March 10, 2021

**Re: Lot 10 Block 3 Unit 22 SAD 228
8001 Camino Alderete
Volcano Cliffs Subdivision
Grading & Drainage Plan
Engineer's Stamp dated: 3-8-21 (D10D003R10)**

GRADING AND DRAINAGE PLAN

MARQUEZ ARAGON RESIDENCE

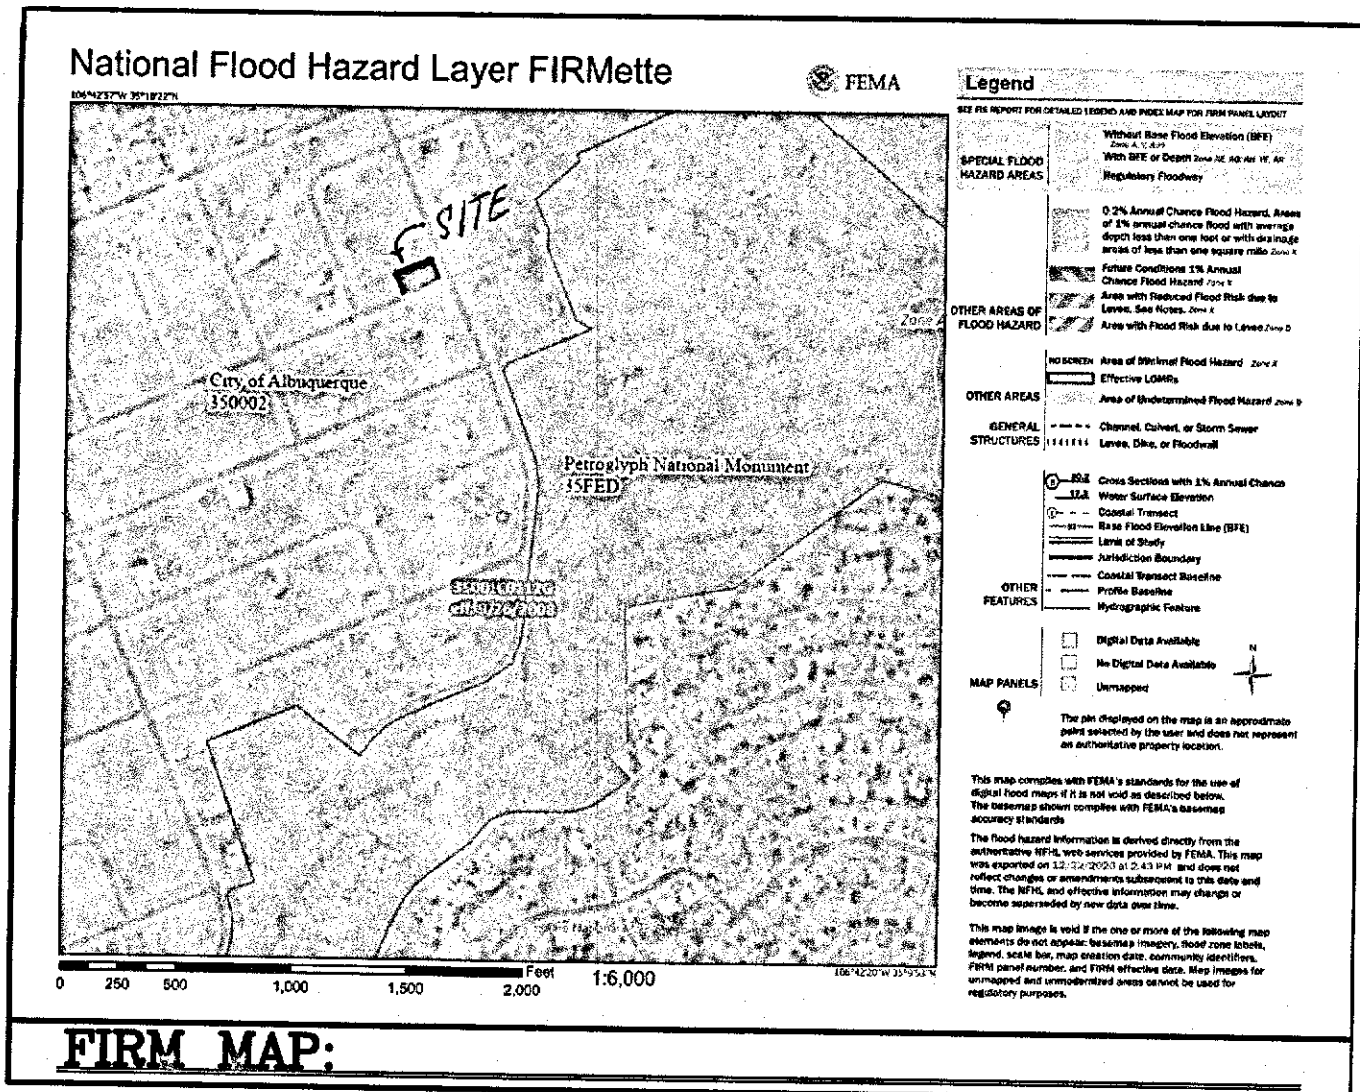
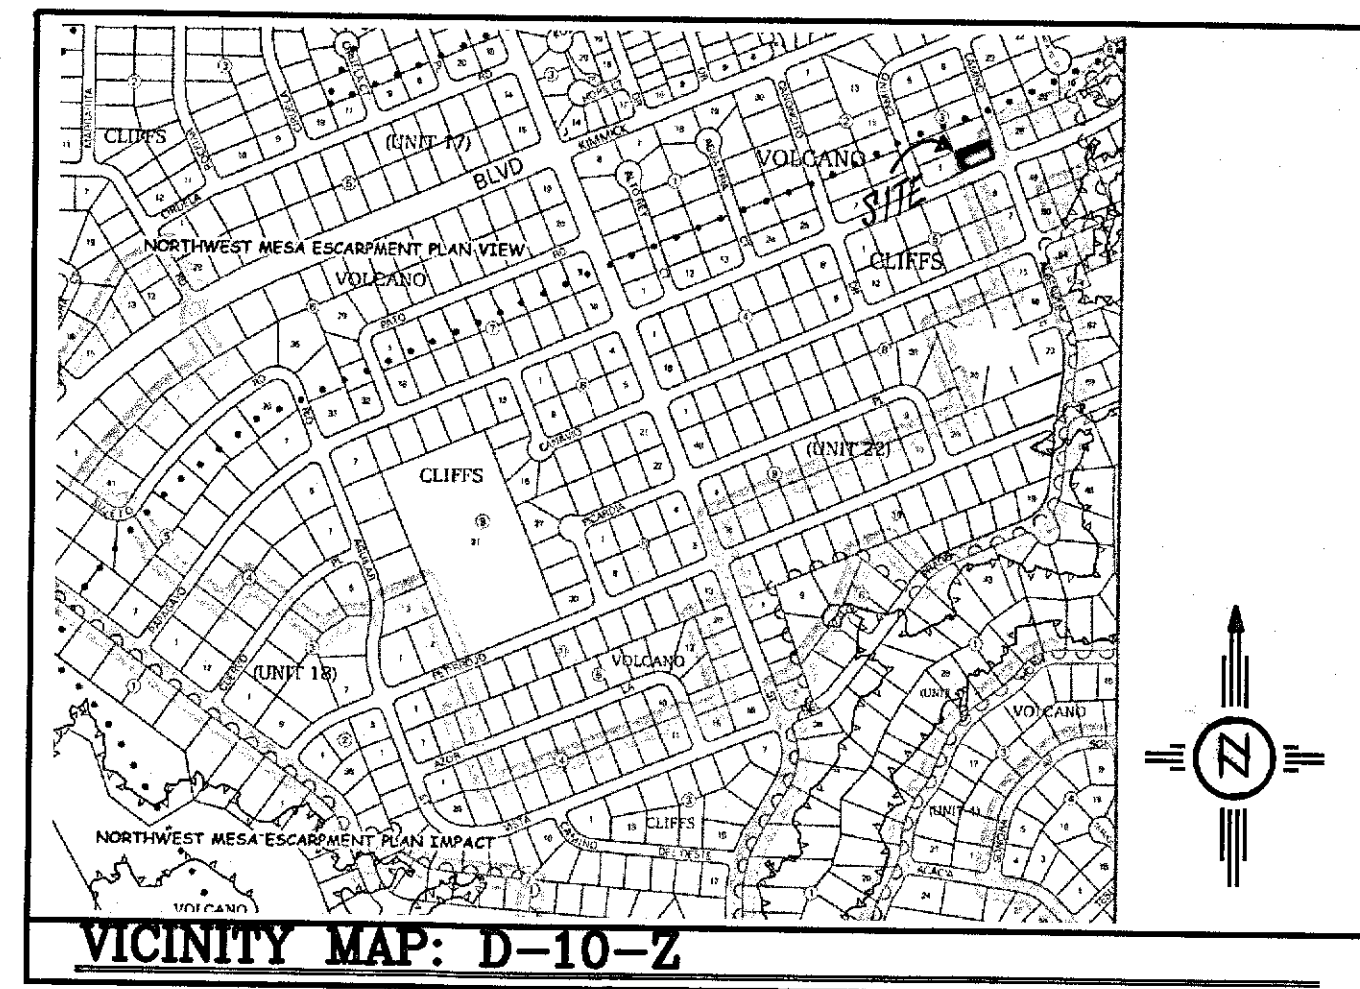
Based upon the information provided in your submittal received 3/3/2021, this plan is approved for Grading Permit.

Prior to Building permit approval a Pad Certification will be required, provided by the Engineer or a registered Land Surveyor.

Advise the owner contractor not to use dirt as a ramp to climb the curb, use lumber or crusher fines for this purpose.

Reiterate to the Owner/Contractor that a separate permit for a garden/retaining wall must be obtained with the approved G&D plan and Pad Certification. Also, if a swimming pool is to be placed the grading and drainage plan will change and will need to be resubmitted.

Prior to Certificate of Occupancy release, Engineer Certification per the DPM checklist is required.
